TOPICS DISCUSSED Aug 26-27 in EXPERT MP00081
MAJM REV BY
 FRED NATICH

DESIGN BRIEF

PROJECT NO. _____ SHORT TITLE Imperial Metals

DESIGN SUBJECT Mt. Polley Mine

AUG 21/96

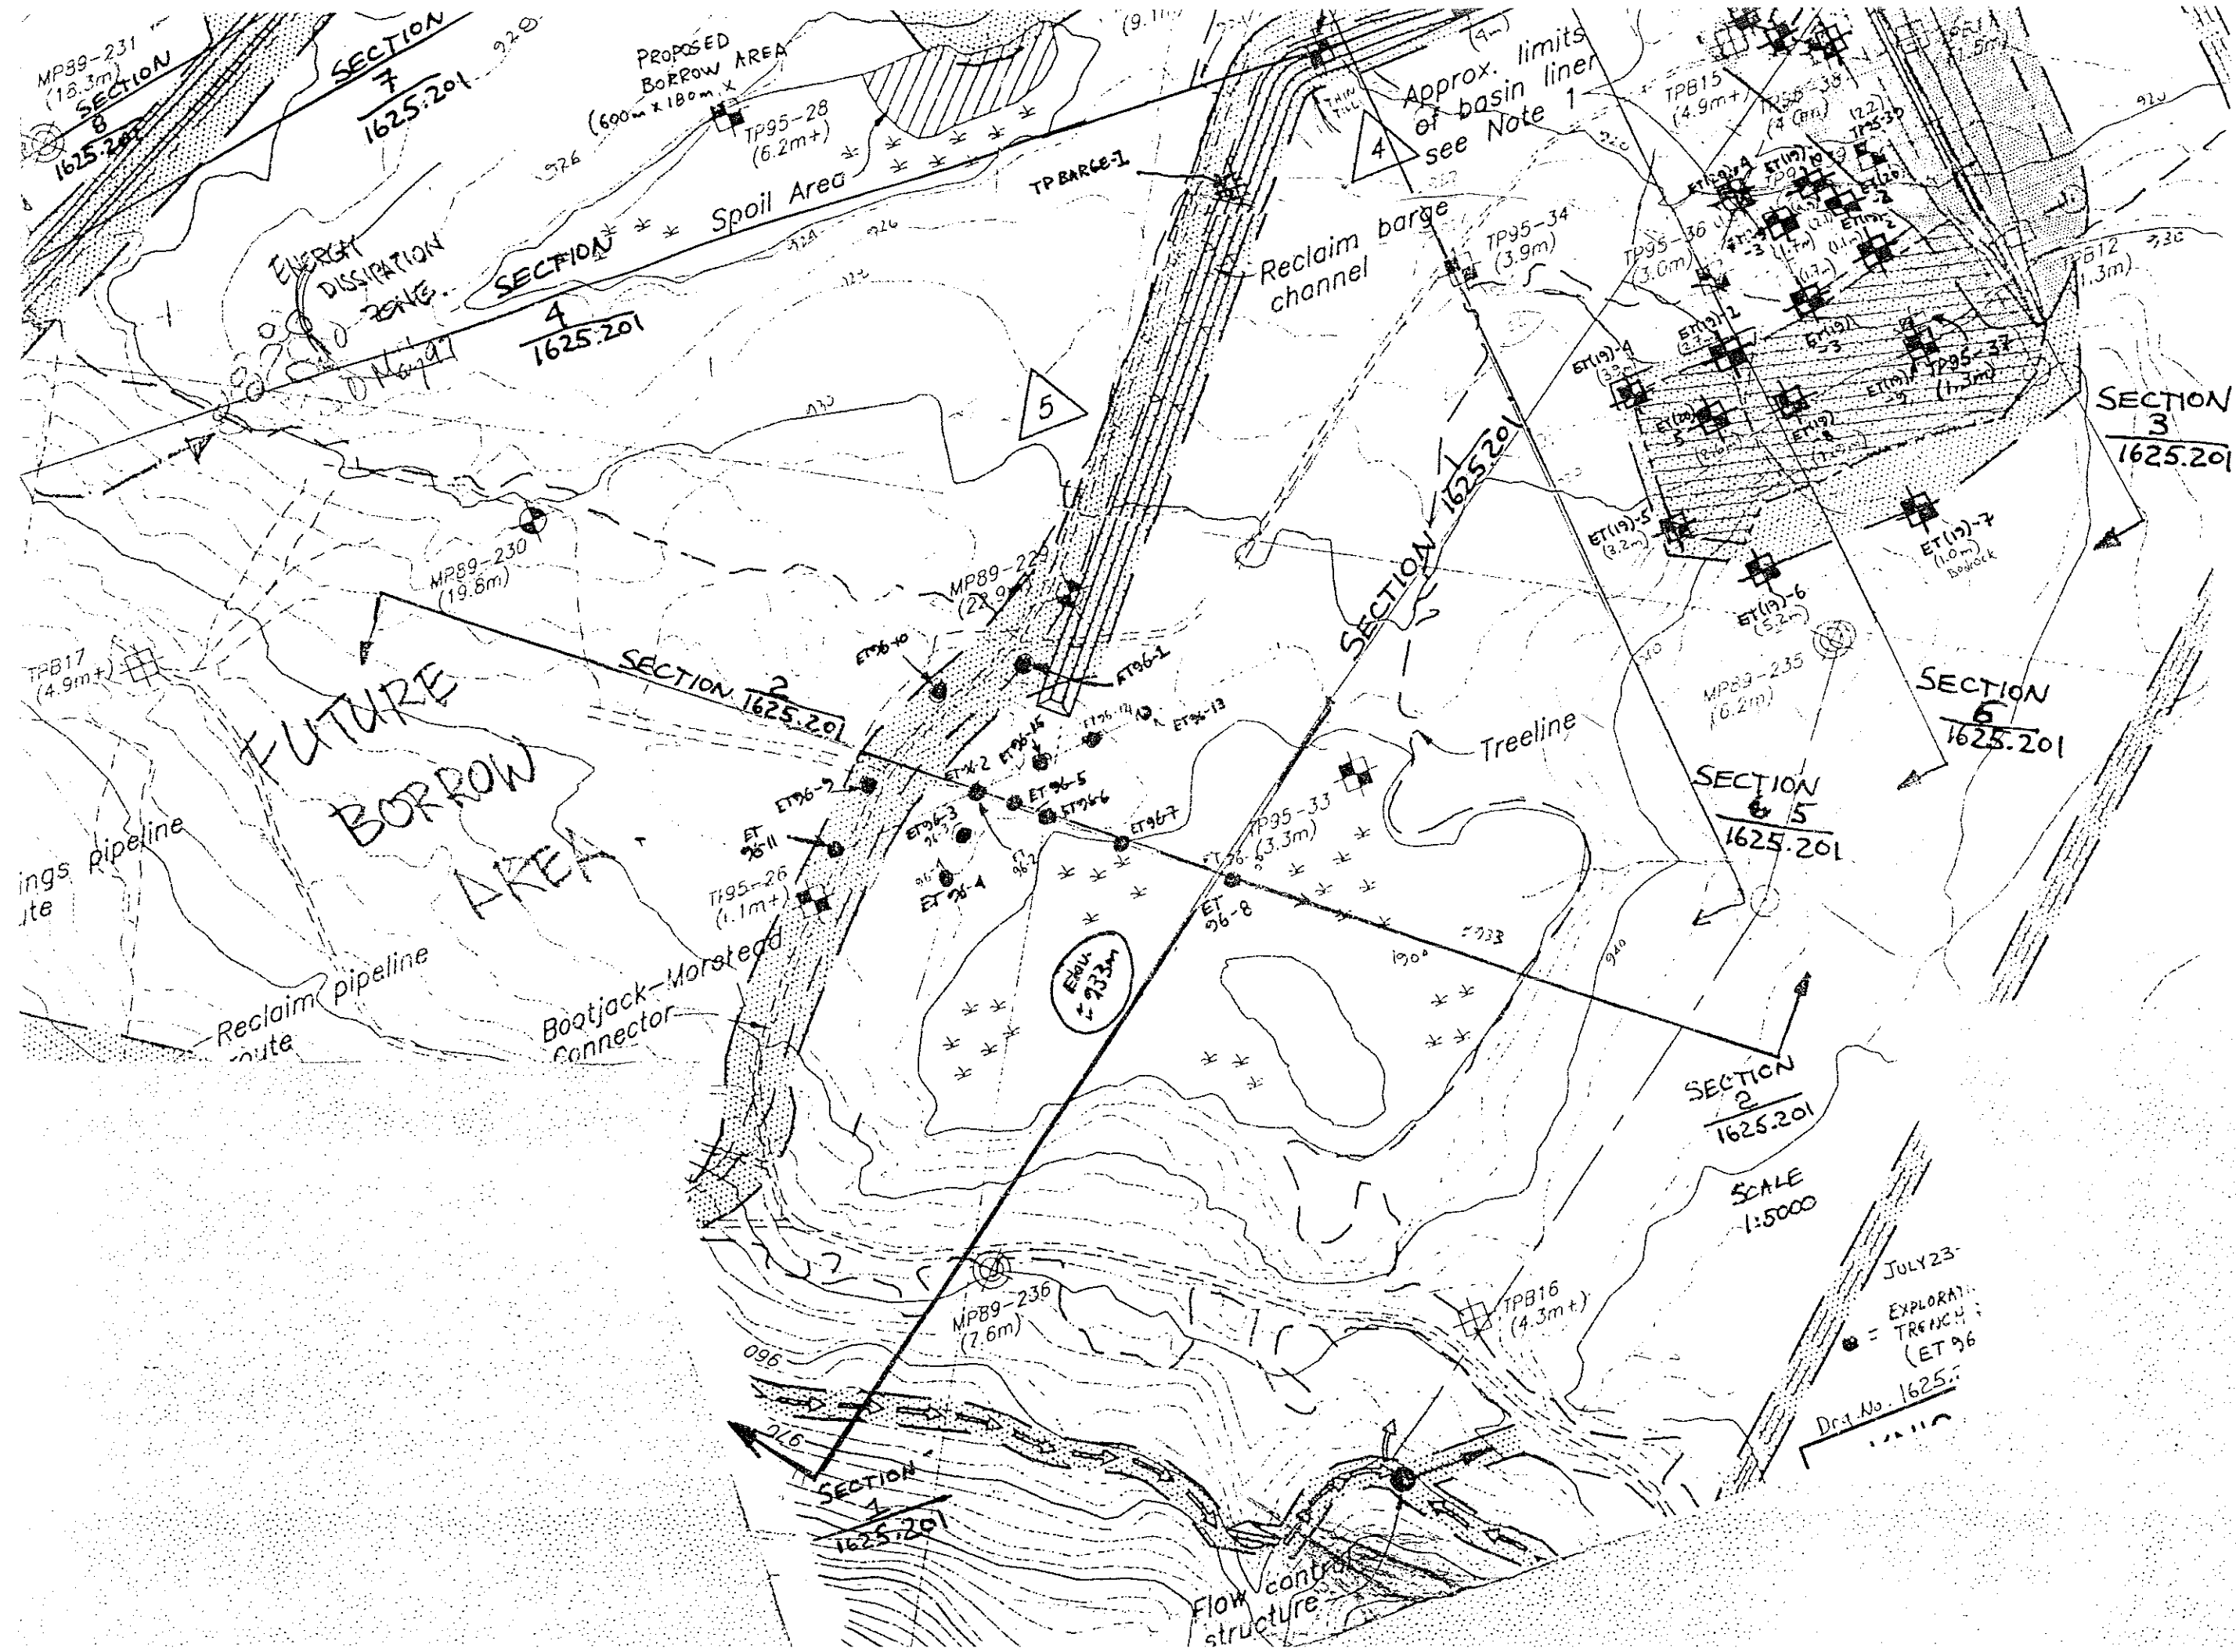
ORIGINAL
NOT NEEDED → 13300 m²
NEEDED → 36500 m²
TOTAL (CONTRACT) → 50,000 m²
Additional (To Date) 13,300 m²
Remaining
